Access Compliance Report

Public Rights-of-Way

(Curb Ramps)

Intersection ID: 22440	Main Street: BELLEVUE_LN	Cross Street: MOORLAND_DR	Location: SW
ADA ID: BA80DF149313	Ramp Type: BlendTrans2	Initial Pass/Fail: Fail	Overall Compliance: No
Severity Score: 21.25			
Codes/Mitigation Info/Possible Solution		Field Measurements/Component Compliance

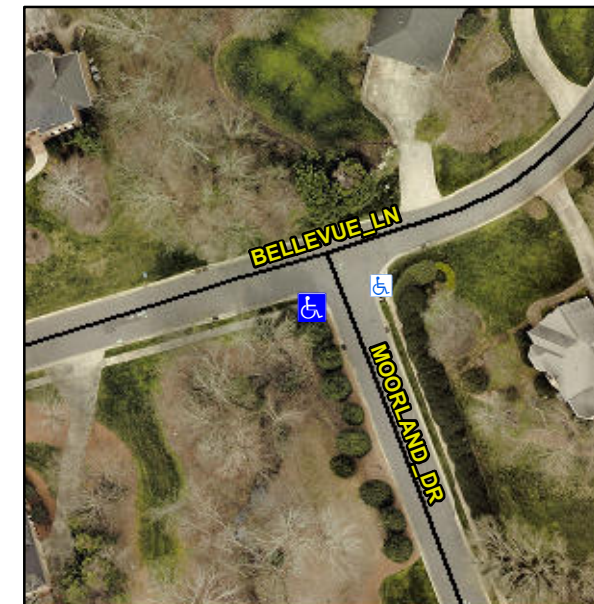
R304.5.1, R304.5.3

Compliance	Description	Data	Compliance	Description	Data
N/A	Ramp Length (in)	56.0	Yes	BlendTrans Slope (%)	1.3
No	Ramp Width (in)	47.0	No	BlendTrans XSlope (%)	5.6
N/A	Flare Type LT	N/A	N/A	Flare Type RT	N/A
N/A	Flare Slope LT (%)	N/A	N/A	Flare Slope RT (%)	N/A
N/A	Flare Traversable LT?	N/A	N/A	Flare Traversable RT?	N/A
N/A	Landing Length (in)	N/A	N/A	DWS Provided?	N/A
N/A	Landing Width (in)	N/A	N/A	DWS Contrast?	N/A
N/A	Landing Slope (%)	N/A	N/A	DWS Length (in)	N/A
N/A	Landing X Slope (%)	N/A	N/A	DWS Full Width?	N/A
N/A	Landing Curb? (Y/N)	N/A	N/A	DWS Offset (in)	N/A
N/A	Shared Landing?	N/A			
N/A	Gutter Ponding?	N/A	N/A	Gutter Slope (%)	N/A
N/A	Gutter Lip Ht (in)	N/A	N/A	Gutter X Slope (%)	N/A
N/A	Painted X Walk1?	No	N/A	Painted X Walk2?	No
	X Walk 1 Direction	To E		X Walk 2 Direction	To N
	X Walk 1 Width (in)	N/A		X Walk 2 Width (in)	N/A
	X Walk 1 Slope (%)	6.9		X Walk 2 Slope (%)	0.3
	X Walk 1 X Slope (%)	1.2		X Walk 2 X Slope (%)	6.6

Remove & Replace Curb Ramp With Two New Directional Ramps or Equivalent.
